## TOLEDO - LUCAS COUNTY PLAN COMMISSIONS

REF: SUP24-00093

SUBJECT: Special Use Permit for a Used Auto Sales at 130 New Towne Square Drive

# LANDSCAPE PLAN

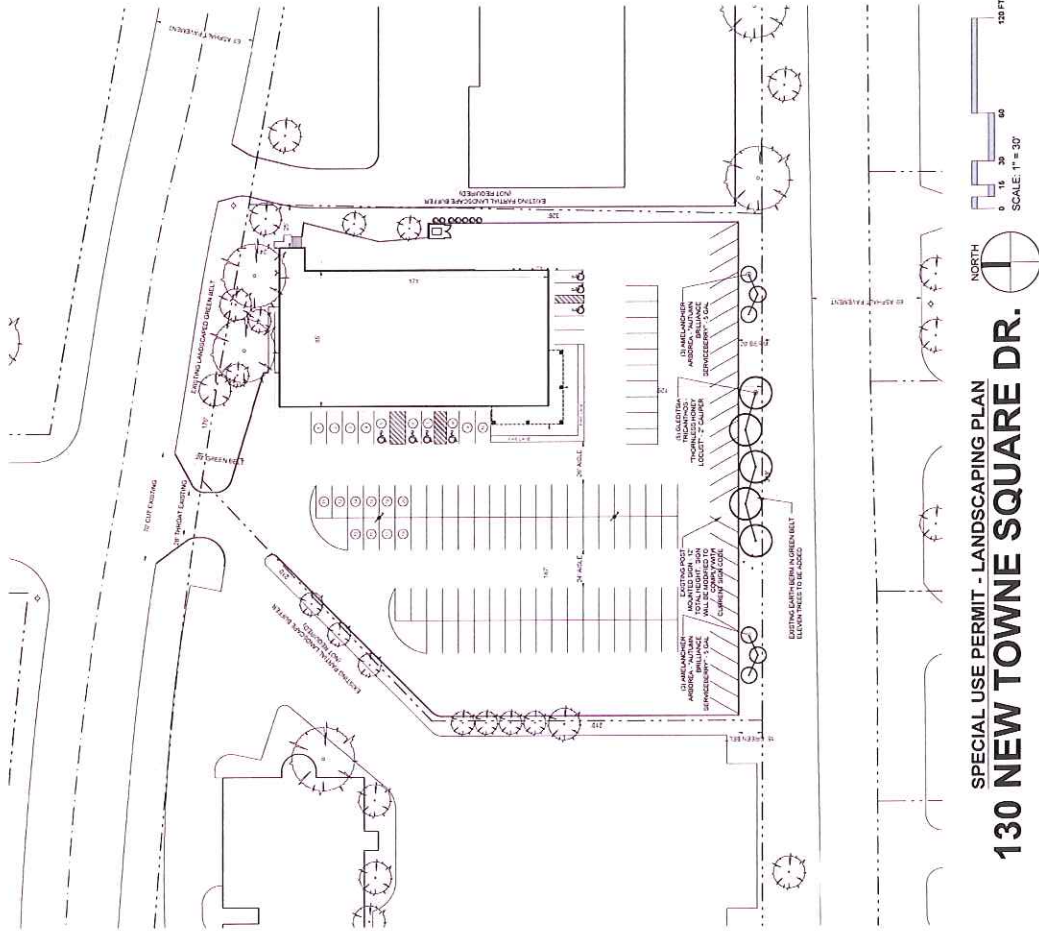
An extensively landscaped frontage greenbelt is required along all public rights-of-way. At least one (1) tree must be provided for every thirty feet (30') of lot frontage, rounded up. The site has  $\pm$ three-hundred-eleven feet ( $\pm$ 311') of frontage on Alexis Road, which requires eleven (11) trees. Eleven (11) trees are shown and have been provided. The site has  $\pm$ one-hundred-sixty-eight feet ( $\pm$ 168') of frontage on New Towne Square Drive, which requires six (6) trees. Seven (7) existing trees are shown on the site plan and complies with the minimum frontage greenbelt requirements.

If a parking lot is proposed in the front of the property, the frontage greenbelt shall include a solid evergreen hedge planting to screen the parking lot so that no headlights of any vehicles can be seen from the public street. A low undulating earth berm may substitute the evergreen hedge if approved by the Plan Director. An acceptable earth berm exists along Alexis Road; however, no such berm exists along New Towne Square Drive. A revised landscape plan shall be submitted depicting a solid evergreen hedge within the frontage greenbelt along New Towne Square Road in front of the parking lot and listed as a condition of approval.

Perimeter parking lot landscaping must be installed along any parking lot area adjacent to a street, place, or driveway, or which is visible from an immediately adjacent property. A minimum of one (1) canopy tree must be provided for each thirty linear feet (30'). A perimeter landscape strip currently exists along the western property line containing eight (8) existing trees. While these trees appear to be on the adjacent property, their existence meets the intent of this provision. Fourteen (14) trees are required along the western property line. The existing trees can be credited for multiple trees per TMC§1108.0407 *Tree Preservation and Credit for Existing Landscape Materials*. In order to count for tree credits, trees must have their species and caliper verified and depicted on a revised landscaping plan. Staff anticipates the existing trees will receive enough credit to meet the minimum fourteen (14) trees required.

Perimeter parking lot landscaping is also required along the eastern property line. There are two (2) existing trees between the parking lot and the property line. No other trees are proposed or shown on the submitted landscaping plan; however, eleven (11) trees are required on this area. While the existing trees may be credited as multiple trees, staff does not anticipate this requirement will be met. As a condition of approval, a revised landscaping plan must be submitted depicting additional trees to meet the eleven (11) trees required. In order to count for tree credits, existing trees must have their species and caliper verified and depicted on a revised landscaping plan.

Perimeter parking lot landscaping must also contain continuous shrubs with a minimum height of eighteen inches (18") when installed so as to achieve full screening at maturity. The submitted landscaping plan shows screening shrubs only along a small portion of the eastern property line. A revised landscaping plan must be submitted showing continuous shrub plantings along both the eastern and western property lines. If the applicant cannot receive permission to plant continuous shrubs within the existing landscape strip on the adjacent property to the west, the landscaping area may need to be expanded onto the subject property.

- a. A fifteen-foot (15') buffer of landscaped frontage greenbelt is required along Alexis Road. At least one tree must be provided for every 30 feet of lot frontage. The frontage greenbelt shall also include a solid evergreen hedge to screen parking in the front of the property and prevent headlights from being seen from the right-of-way. **Acceptable as depicted on landscaping plan. Berm is a suitable substitute for the evergreen hedge.**

- b. A fifteen-foot (15') buffer of landscaped frontage greenbelt is required along New Towne Square Drive. At least one tree must be provided for every 30 feet of lot frontage. The frontage greenbelt shall also include a solid evergreen hedge to screen parking in the front of the property and prevent headlights from being seen from the right-of-way. **Not acceptable as depicted. A revised landscaping plan shall be submitted to the Plan Director depicting a solid evergreen hedge within the frontage greenbelt along New Towne Square Road where the parking lot is visible.**

- c. Perimeter parking lot landscaping is required along the western property line. A minimum of one (1) canopy tree must be provided for each thirty linear feet (30'). **Not acceptable as depicted. Fourteen (14) trees required. Existing trees on the abutting property may be credited for multiple trees per TMC§1108.0407. In order to count for tree credits, trees must have their species and caliper verified and depicted on a revised landscaping plan.**

- d. Perimeter parking lot landscaping is required along the eastern property line. A minimum of one (1) canopy tree must be provided for each thirty linear feet (30'). **Not acceptable as depicted. Eleven (11) trees are required. Existing trees on the abutting property may be credited for multiple trees per TMC§1108.0407. In order to count for tree credits, trees must have their species and caliper verified and depicted on a revised landscaping plan.**

- e. Perimeter parking lot landscaping along the eastern and western property lines must contain continuous shrub plantings with a minimum height of eighteen inches (18") when installed so as to achieve full screening at maturity. **A revised landscaping plan shall be submitted to the Plan Director depicting continuous shrub plantings along both the eastern and western property lines. Western property line shrub plantings may be depicted on the adjacent property if permission is given by the adjacent property owner.**
